ATTENTION CORTLAND DEVELOPERS

Important Information Enclosed Regarding: Memory, Sound & Compatibility

SOUND GLU FIX

(Green pre-productions boards only)

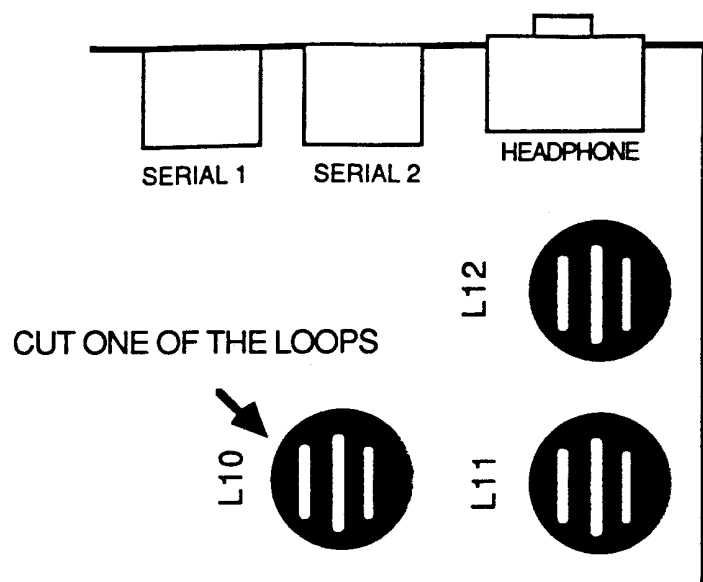
The following circuit modification fixes a timing problem with the sound glu, and a board layout error. The symptoms of the timing problem show up as loss of data in the sound memory. This can cause a clicking sound or an oscillator to stop unexpectedly. To correct this problem follow the instructions below.

1. Be sure you are competent to cut traces and solder wire, if you are not, find someone who is.
2. With the board still in the case, carefully cut the trace just above pin 1 of U35.
3. Solder a wire to pin 1 of U40 and connect the other end to the feed-through just above U37.
4. Solder a wire to pins 2 and 3 of U40 and connect the other end to the feed-through next to pin 1 of U35.
5. Cut one of the wire loops at the top of inductor L10.
